PRODUCT: UltraCade & Dragon's Lair S300 Computer

BULLETIN: SB-013

ISSUE: UltraCade S300 – Cooling Solution

DATE: 10-12-2005

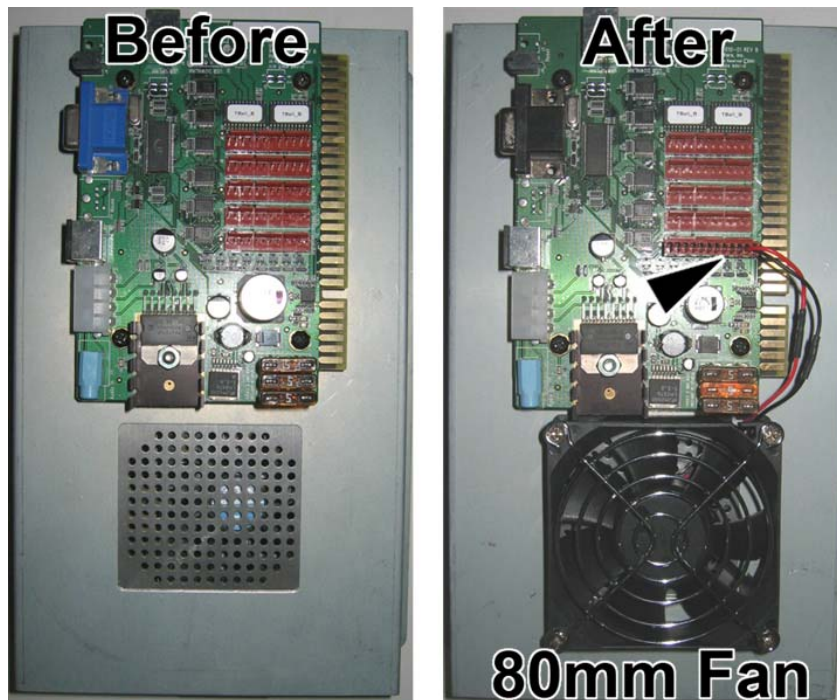
UltraCade Technologies offers a new cooling solution for the UltraCade and Dragon's Lair owner who has the S300 (Sumicom) computer as the heart of their game. The S300 computers are shipped with the UltraCade conversion kits and Dragon's Lair games. The S300 computer chassis are designed as a heat sink and can run very warm in warmer climates. UltraCade Technologies now offers an S300 bracket with an attached fan that dramatically decreases the operating temperature of the S300 chassis for \$25 USD.

For those who do not want to purchase the modified S300 bracket, implementation of the cooling solution is relatively straightforward. The procedure includes mounting an 80mm case fan to the I/O bracket that forces cool air into the S300 computer chassis. Power for the fan comes from the USBlinx I/O card on the row of pins labeled "Digital Out" shown by the arrow in the picture above. Pin #1 = Ground, Pin #2 = +12 Volts. Be aware when mounting the fan that it may interfere with the alignment of the audio cable on the USBlinx board.

For those people who are not comfortable with modifying their existing bracket, please contact the **Technical Support** department of UltraCade Technologies to order the modified S300 I/O bracket.
